SACOMBE HOUSE

EXISTING AND PROPOSED
NORTH ELEVATION

DR-200-NORTH | B |

Proposed North Elevation

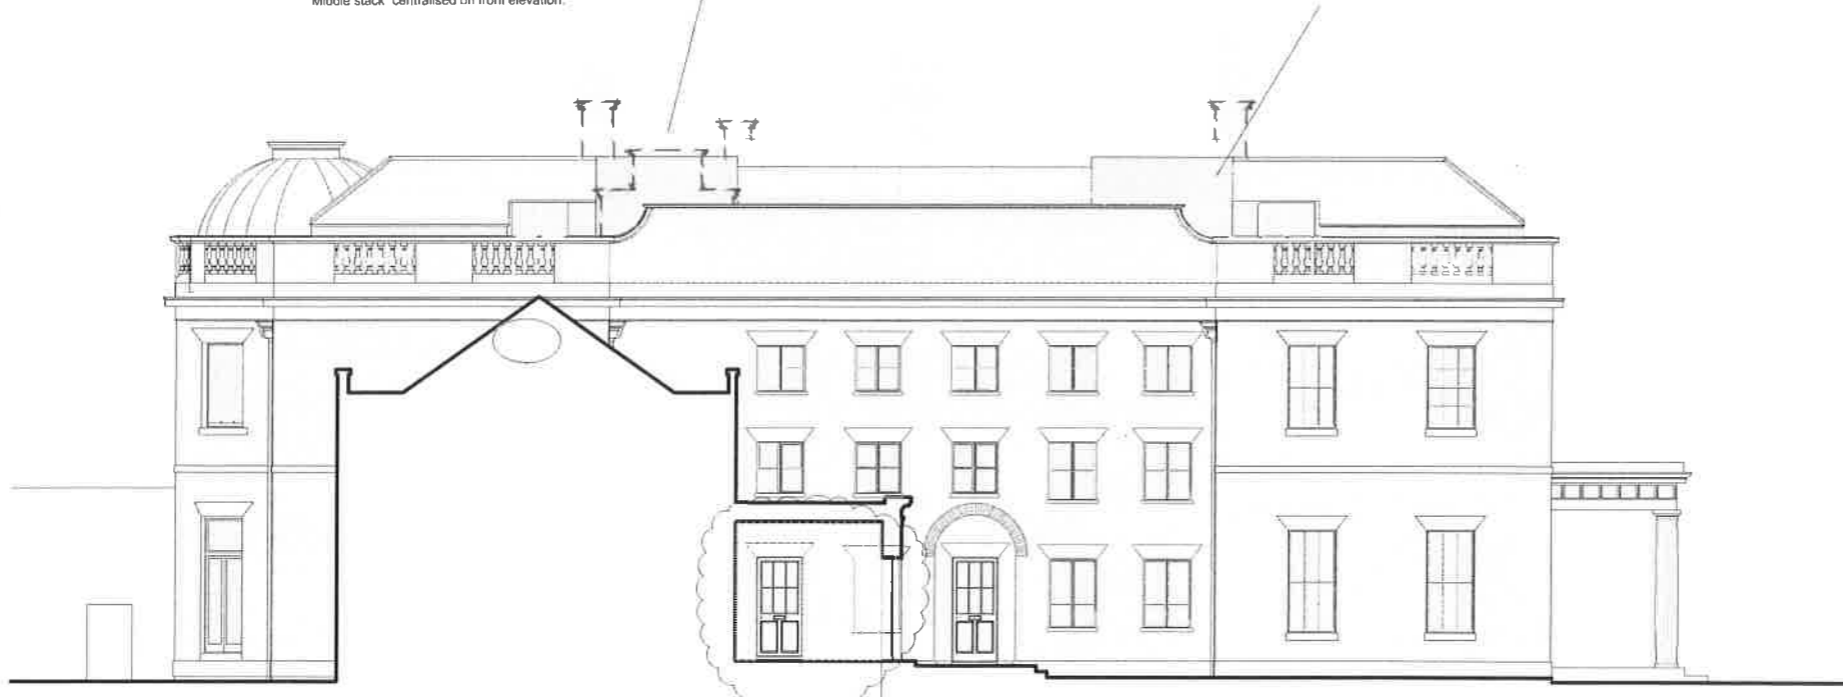
Existing chimney stacks (which were rebuilt following the fire in 1905) to be raised by 770mm to match original in colour, texture and lute pointing style. Stacks to have new traditional Georgian clay pots. Middle stack centralised on front elevation.

Replace Edwardian rooflight over back stair with new traditional painted timber roof lantern. Details to be provided.

Reciprocal symmetrical enclosure visible only on rear North Elevation necessary to hide the passenger lift overan consented under application ref: 3-11-2088FP

The design for the arcade is to revert to the consented scheme under the Application Ref:3/12/0366/LB
